SUNDRY NOTICES AND REPORTS ON WELLS

Nash 56, 57, 58 Battery
Eddy County New Mexico
Install Emergency Flare

**Sundry dated 11/07/2012 Installation of permanent flare on the Nash Unit 56,
57, 58 Tank Battery**

Lease Flow Diagram

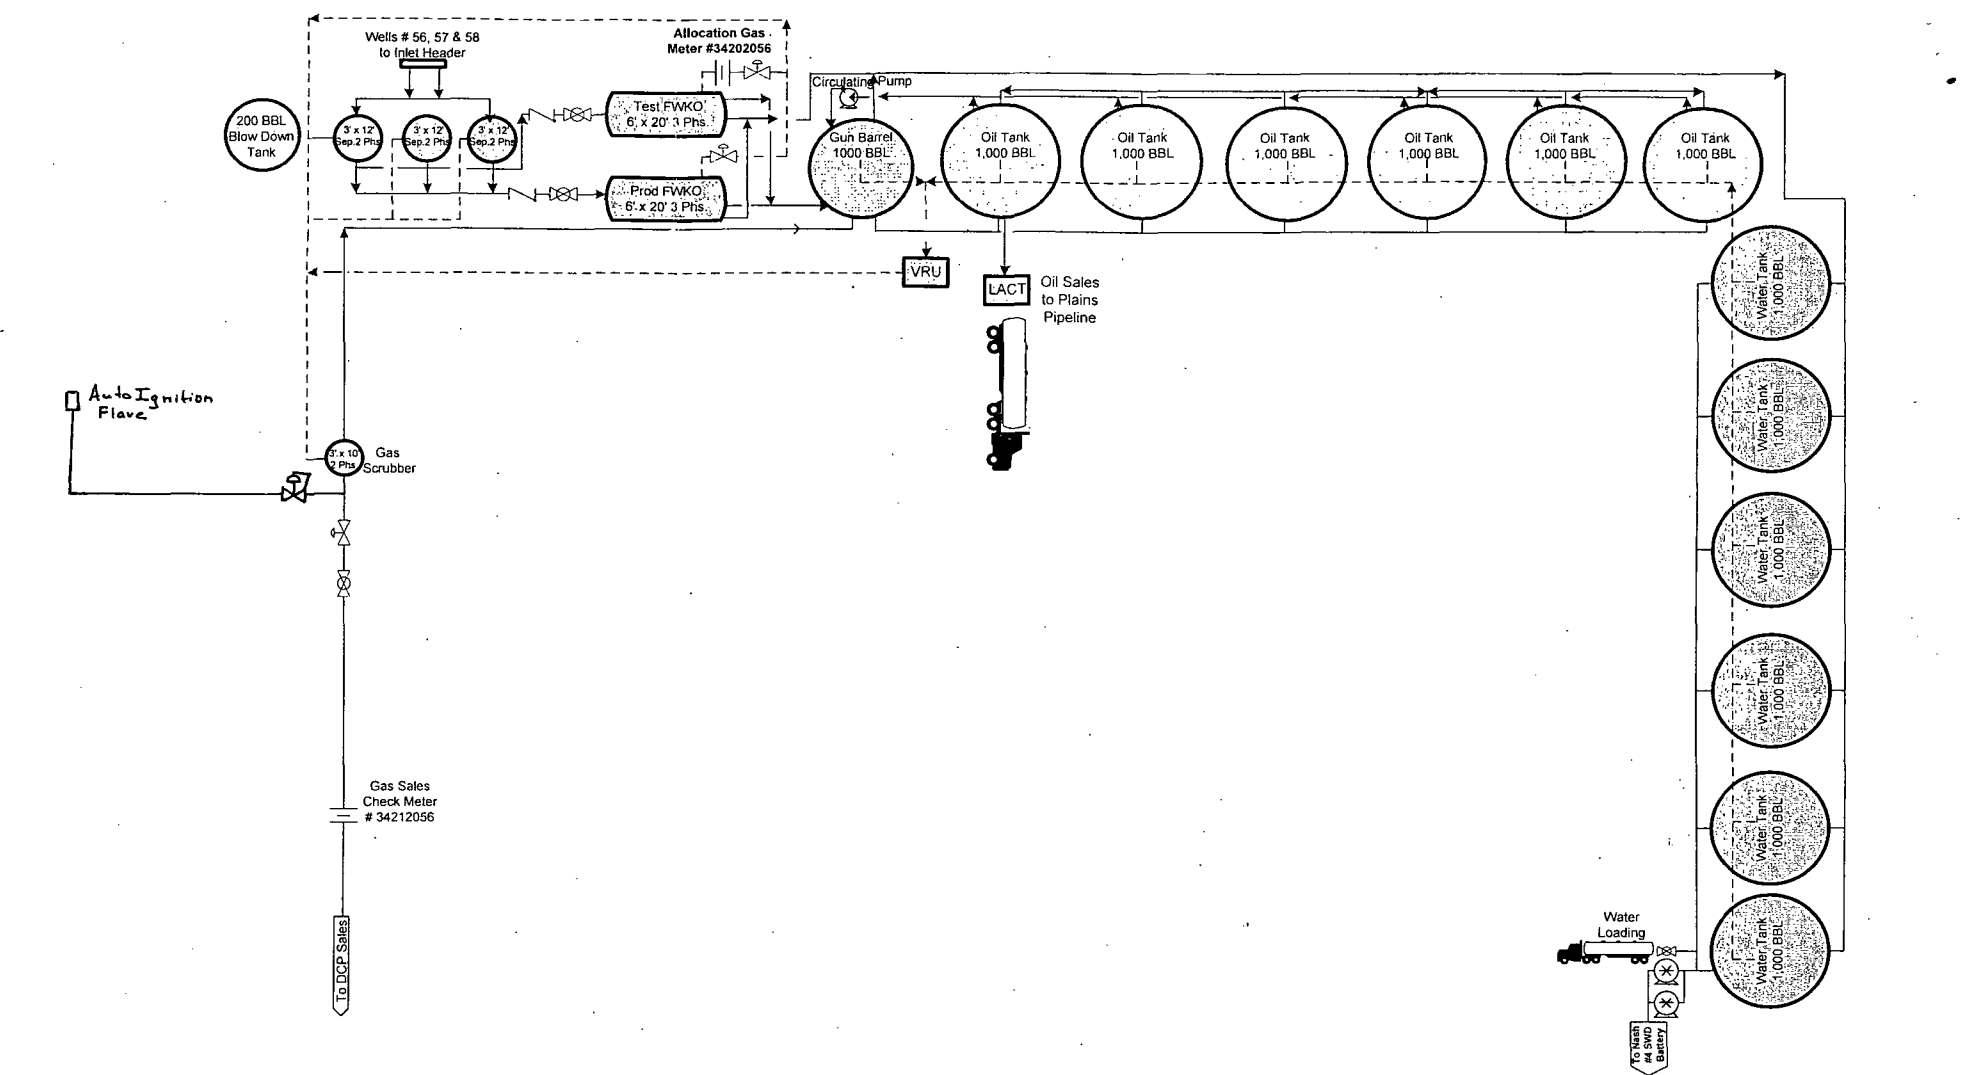
1. Install gas meter on vent/flare line to measure gas prior to venting/flaring operations if it is not equipped as such at this time. Gas meter to meet all requirements for sale meter as Federal Regulations and Onshore Order #5.
2. This approval does not authorize any additional surface disturbance other than what is being approved by the Sundry
3. Submit updated facility diagram as per Onshore Order #3. After the permanent flare is installed
